FREMANTLE INNER HARBOUR DEEPENING PROJECT

FREMANTLE PORT AUTHORITY

Report and Recommendations
of the
Environmental Protection Authority

Environmental Protection Authority
Perth, Western Australia
Bulletin 342 August 1988

Figure 2 Preliminary concept plan for proposed reclamation and small craft harbour. (Source: FPA, 1988)

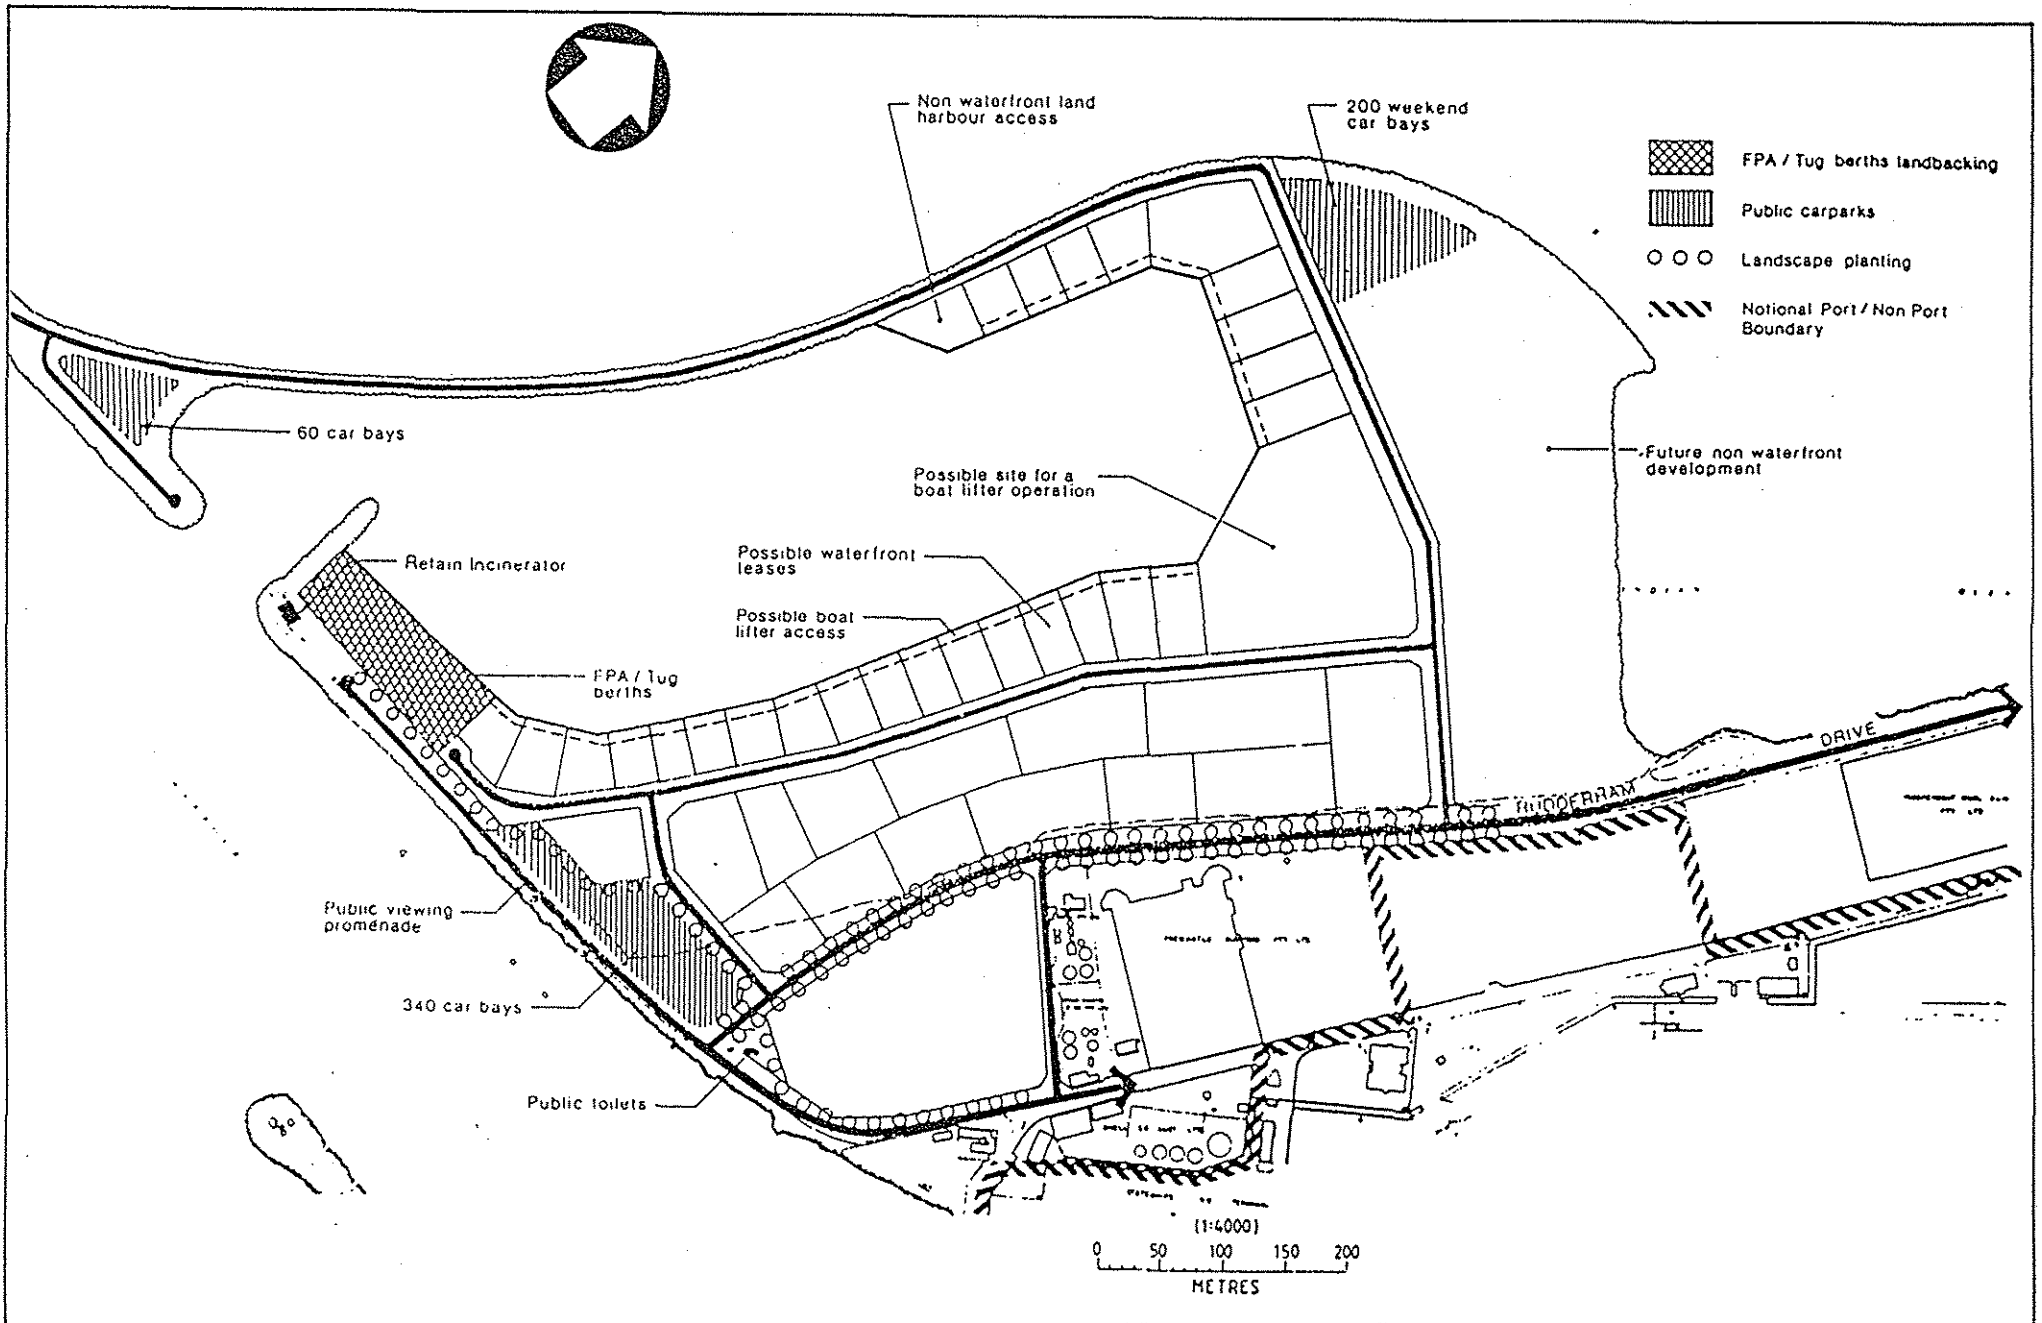
(Note: Original breakwater design as presented in PER now slightly modified.)

- . A marina should be built at the northern end of the industrial area by extending the breakwater to within a short distance of Rudderham Drive and creating an enclosed area within which jetties and a boat ramp could be developed. Relocation of the northern carpark to this marina would be included.

- . This proposal will eliminate one of the best shaped surfing waves in the metropolitan area. The design should incorporate provision for a replacement surf area at the northern end of the facility, by constructing a shallow sand bar at the northern point.

26. The provision of a marina on the northern side of the proposed development is not contained in the development plan. The suggestion to establish a marina is viewed with concern since it would introduce a substantial volume of non-commercial traffic to an area where improved traffic flow is an essential element of the overall port development and rationalisation plan. In addition, a northward extension could encroach upon the environment of Port Beach.

AMENDED SEA WALL, BUND AND LAND RECLAMATION TIMETABLE

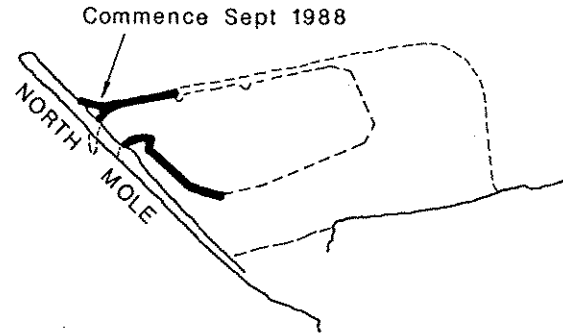
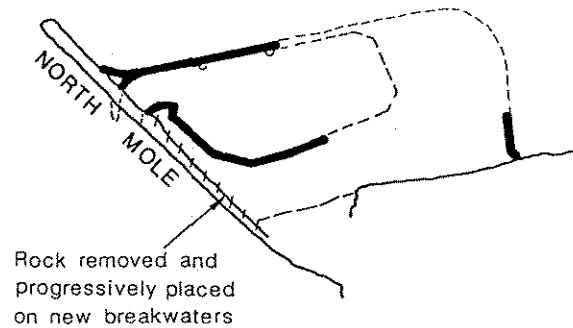
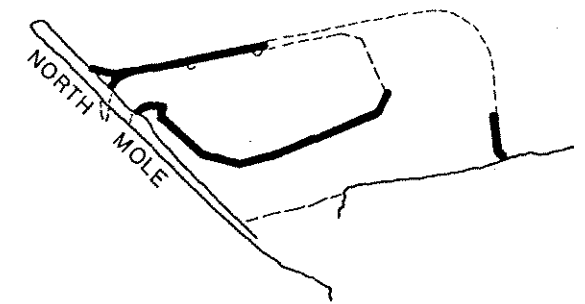
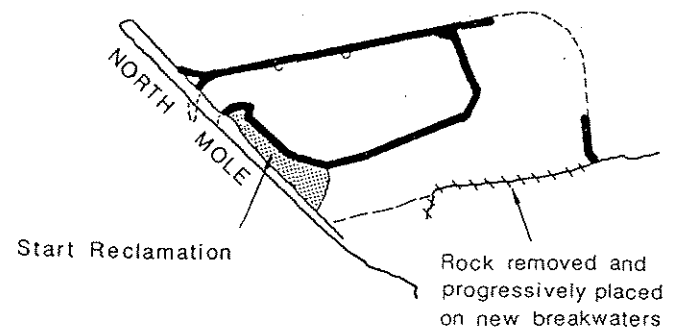
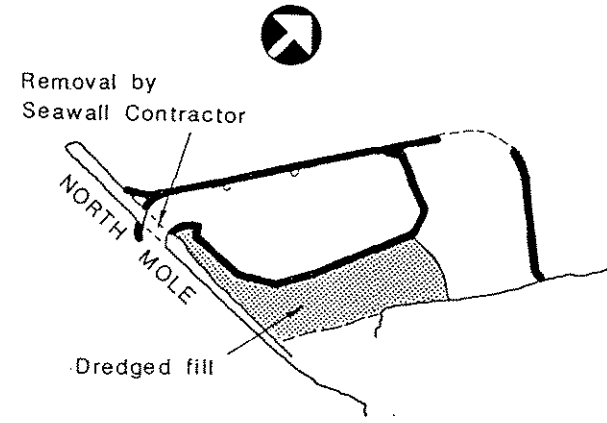
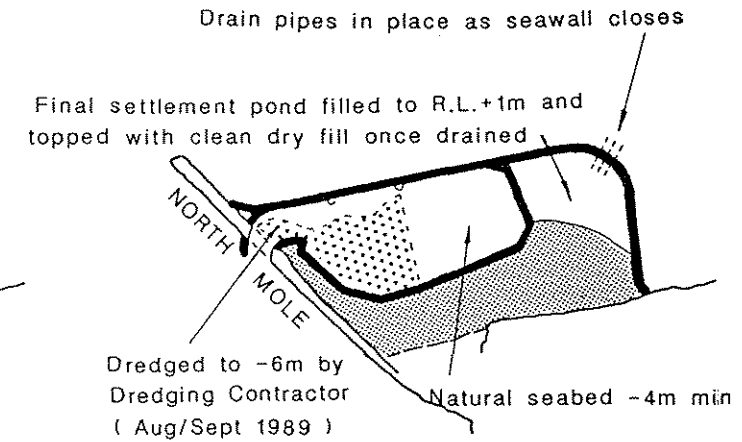
In a separate development, and as part of the process of writing tender documents and interfacing with Contractors tendering for the sea wall contract, it became clear to the Port Authority that an alternative construction sequence to that modelled would further reduce the effective risk of damage to the bund wall in the event that the sea wall construction was delayed and an early winter (1989) storm occurred. We therefore explored ways of modifying the construction sequence and have come up with that depicted on the revised drawing, which I enclose with this letter.

This new sequence virtually eliminates any risk of damage to the armour of the bund wall and the unprotected inside face of the sea walls whilst also providing earlier alternative access (in a loop along the bund wall and sea walls) to the end of North Mole permitting early excavation of the cut through North Mole. Final closure of the sea wall is planned to be on the North West corner. With a delayed start to dredging of 2 months (now due to commence March 1989) the sea and bund walls will be well advanced to provide complete containment of dredge spoil.
